HOCKEY TOP RAILS – OLD vs. NEW (picture worth 1000 words)

CORNER PROTECTORS – OLD vs. NEW (picture worth 1000 words)

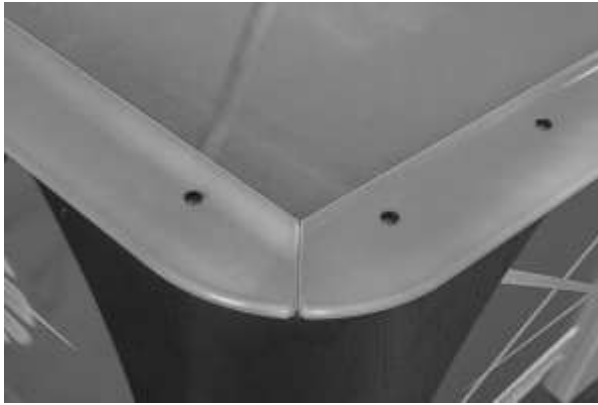
Starting in 2011, Dynamo introduced rounded corner top rails (shown at left), for a more attractive look that eliminated the need for a corner protector.

As of 2013, the older style rails are discontinued and have been depleted from inventory.

HERE'S THE ISSUE: As seen in the photo shown at the right, you cannot mix new style rounded and old style rails on the same corner of a table. The corner protector will not fit the new rail, and from the shape of the old rail it is pretty clear why protectors are important.

This means if you need to replace one goal end rail, you'll also need to replace that table's side rail and opposite goal end rail so the rail corners mate up.

Please don't order the new style rail thinking you can make it work. Several have tried. None have succeeded.
